Service Bulletin **SB 2X-78-04 R1**

Model SR22

ATA 78-20: Exhaust Replacement of #4 and #5 Exhaust Headers

Figure 01 - Exhaust Header Alignment and Engagement

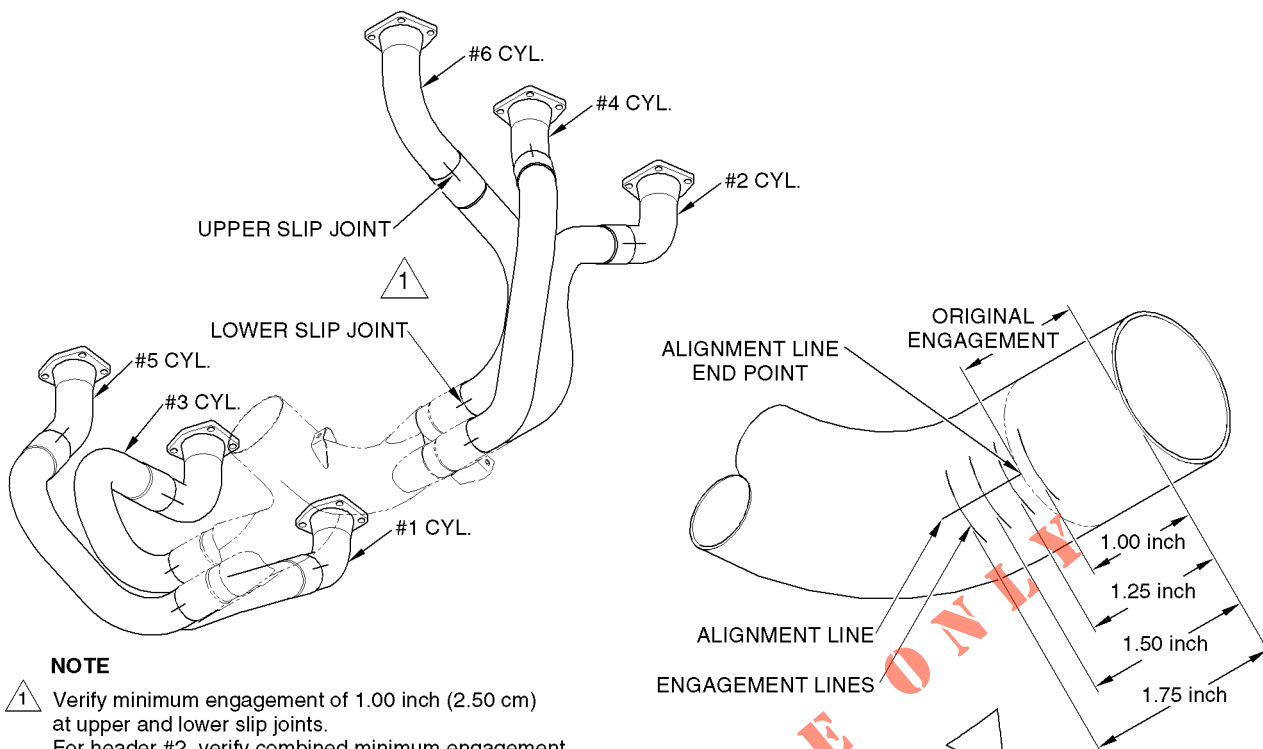
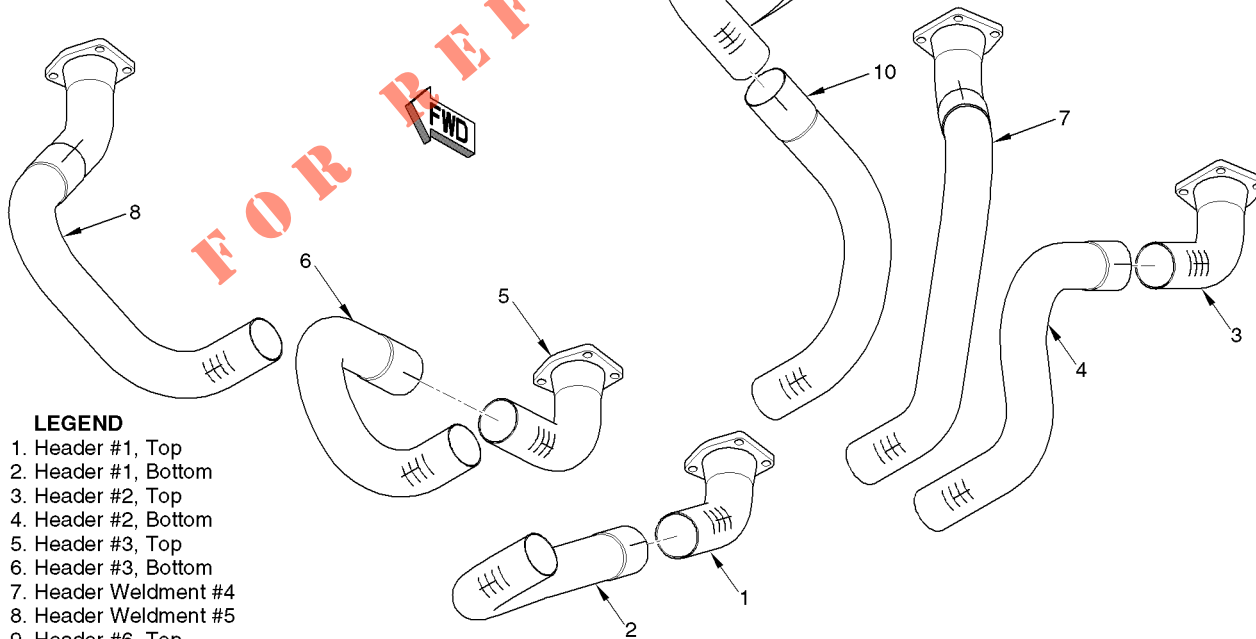
The engagement between the upper and/or lower slip joints on the #4 and #5 exhaust headers may fail on some of the affected airplanes. This condition has the potential of scorching or damaging engine components, cowling and/or other components. To correct this condition, this Service Bulletin replaces the existing #4 and #5 exhaust header assemblies with single-piece header weldments.

- E. Carefully mark and remove exhaust header assemblies. (See Figure 01)
 - 1. Acquire necessary tools, equipment, and supplies.

2. At all header assemblies, make alignment line perpendicular to upper and lower slip joints.
 3. Remove exhaust system. (Refer to AMM 78-10)
 4. Determine original engagement measurement for each upper and lower slip joint by measuring from alignment line end point to end of pipe. Record measurements on the Compliance Response Card.

- 1 Verify minimum engagement of 1.00 inch (2.50 cm) at upper and lower slip joints.
 For header #2, verify combined minimum engagement of upper and lower slip joints is not less than 2.50 inches (6.25 cm).
 For headers #1, #3, and #6, verify that no more than one of the three headers (#1, #3, #6) have a combined minimum engagement of upper and lower slip joints of not less than 2.50 inches (6.25 cm).
 For remaining headers, verify combined minimum engagement of upper and lower slip joints of not less than 2.75 inches (7.00 cm).

- G. For replacement #4 and #5 header weldments, mark engagement lines on lower slip joints as follows:
1. From end of pipe working up, mark engagement lines perpendicular to pipe centerline at intervals of 1.00 inch (2.50 cm), 1.25 inch (3.18 cm), 1.50 inch (3.80 cm), and 1.75 inch (4.45 cm).

- J. For #4 and #5 header weldments, inspect for minimum engagement as follows:
1. Verify minimum engagement of lower slip joints is not less than 1.00 inch (2.50 cm).

2. If #4 and #5 headers are not welded, verify upper and lower slip joints have a 1.00 inch (2.50 cm) minimum engagement and a combined minimum engagement 2.75 inch (7.00 cm).
